ANP-10272
Revision 10

**Software Program Manual for TELEPERM XS™ Safety Systems
Topical Report**

AREVA NP Inc.

Figure 3-1 - Annotated Version of Figure 2.2 from the TELEPERM XS Topical Report

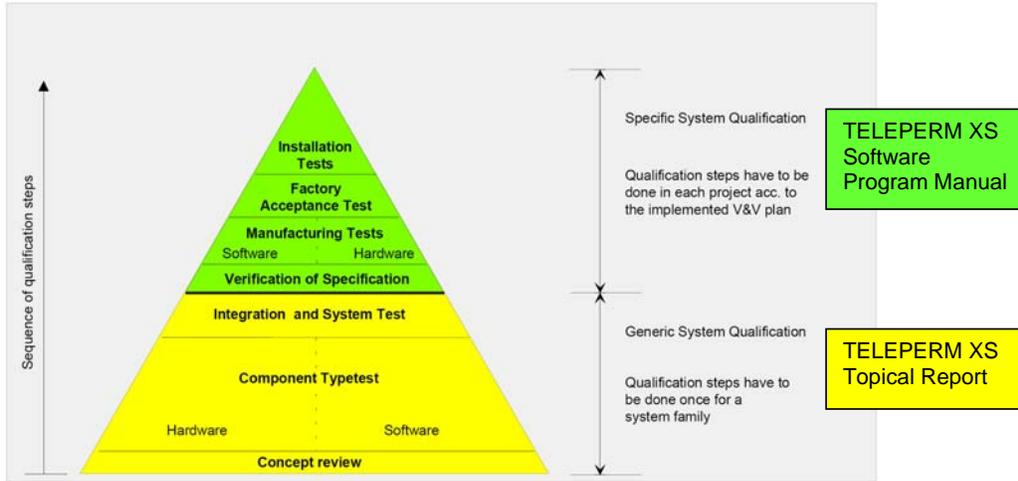
Comment [m14]: Section added based on responses to RAIs 2 and 60 and follow-up commitment after NRC audit in December 2007.
